APPENDIX A

MODIFIED CONTAINMENT SPRAY SYSTEM

FIGURE 1 - CONTAINMENT/CORE SPRAY SYSTEM

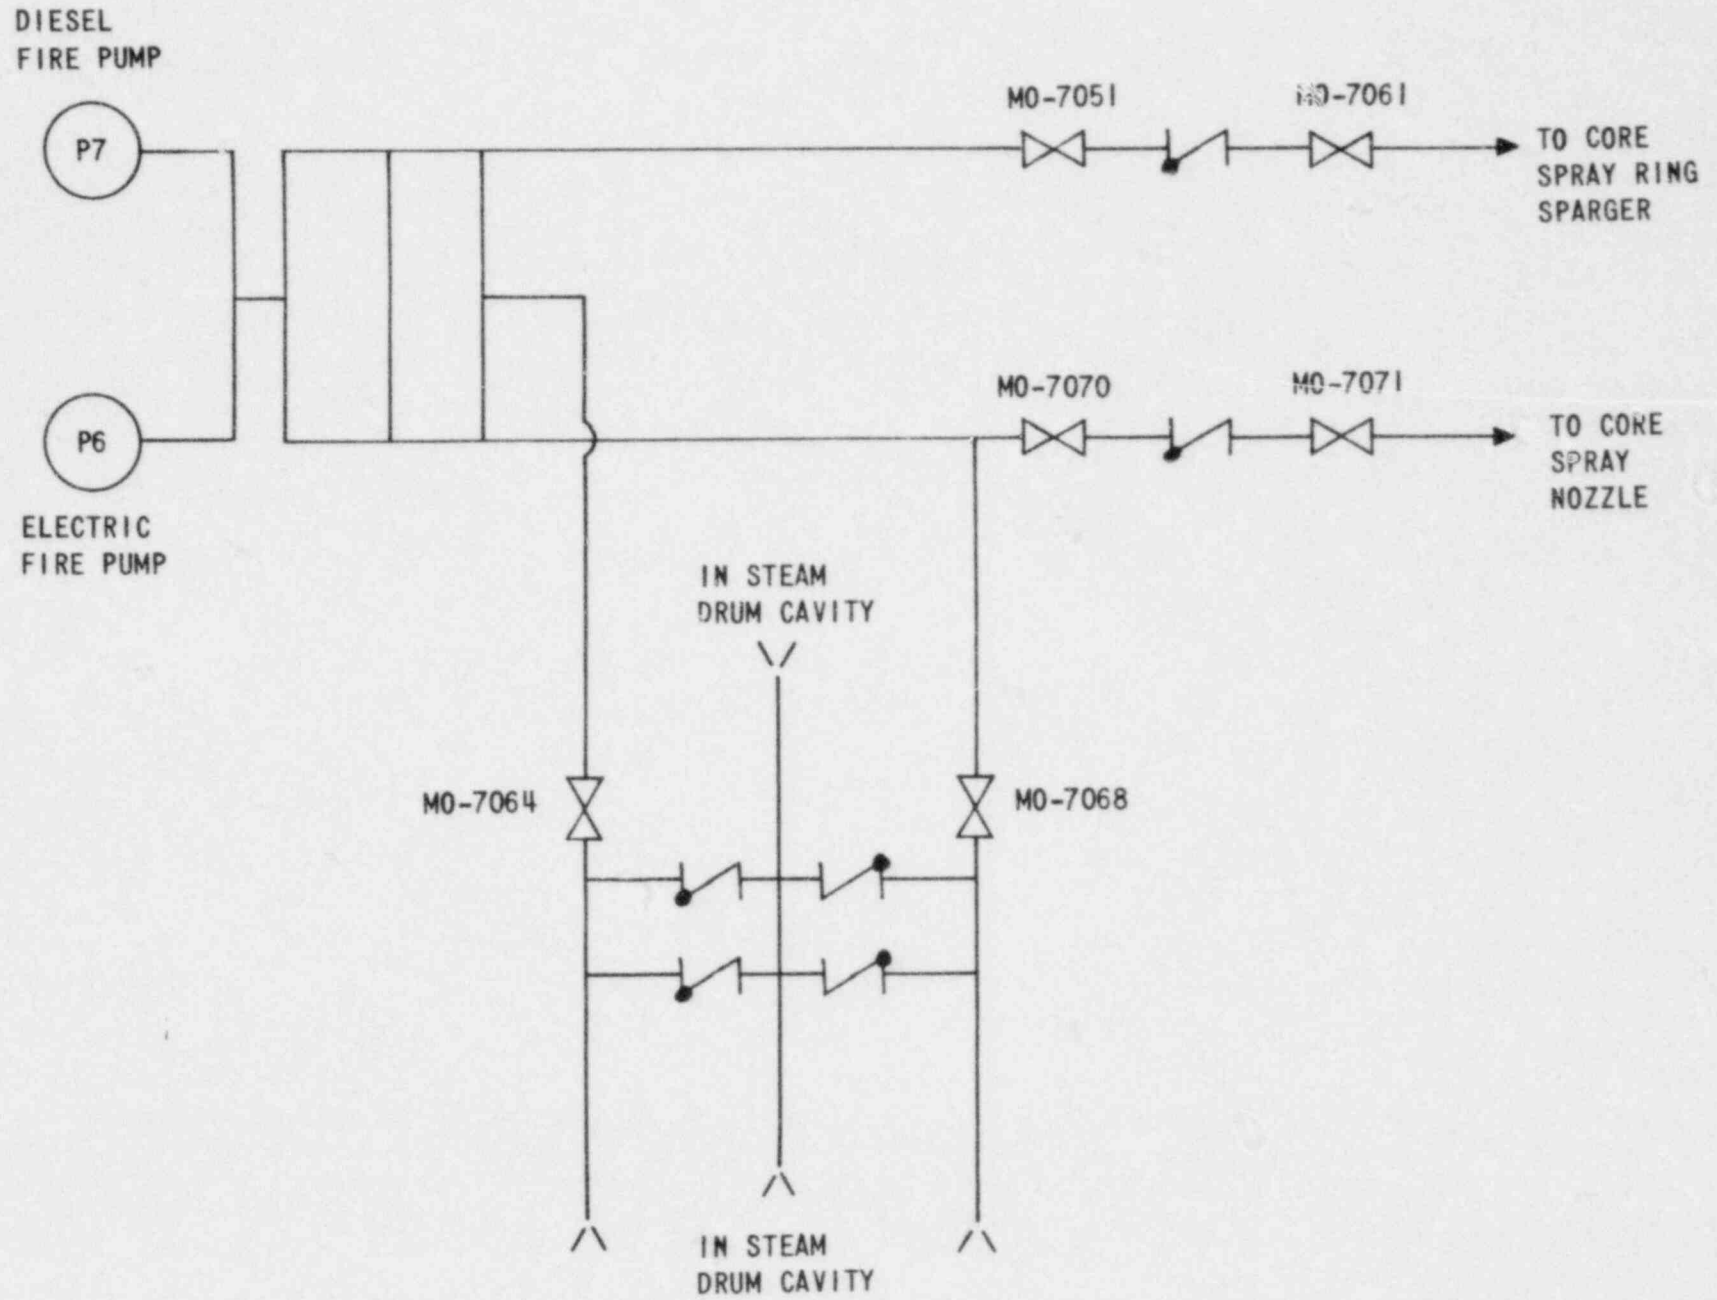
In the modified containment spray system (shown schematically on Figure 1), motor-operated valve MO-7064 opens automatically on a containment pressure of ≤ 2.2 psig following a reactor coolant line break. Spray flow is provided to both inside and outside the steam drum cavity. The spray nozzles are sized such that sufficient core spray flow is still maintained. After 15 minutes, valve MO-7068 is manually opened which provides sufficient spray for iodine washout. Also, in the event that MO-7064 should fail, MO-7068 can be used as a manual backup.

The above modification consists of four changes to the existing containment spray system:

1. The 15-minute time delay on MO-7064 is removed. Thus, containment spray is promptly initiated at a containment pressure of ≤ 2.2 psig.
2. The circuit breaker to MO-7068 is enabled such that this valve can be manually opened from the control room. The valve will be manually opened 15 minutes after reactor scram due to a LOCA or SLB to wash out iodine. It can also be used as a manual backup in the event of a failure of MO-7064.
3. Spray lines are extended from the containment spray headers to the steam drum cavity such that containment spray will simultaneously spray inside and outside the cavity.
4. All the containment spray nozzles will be replaced with nozzles which will provide adequate containment spray while at the same time maintaining sufficient core spray.
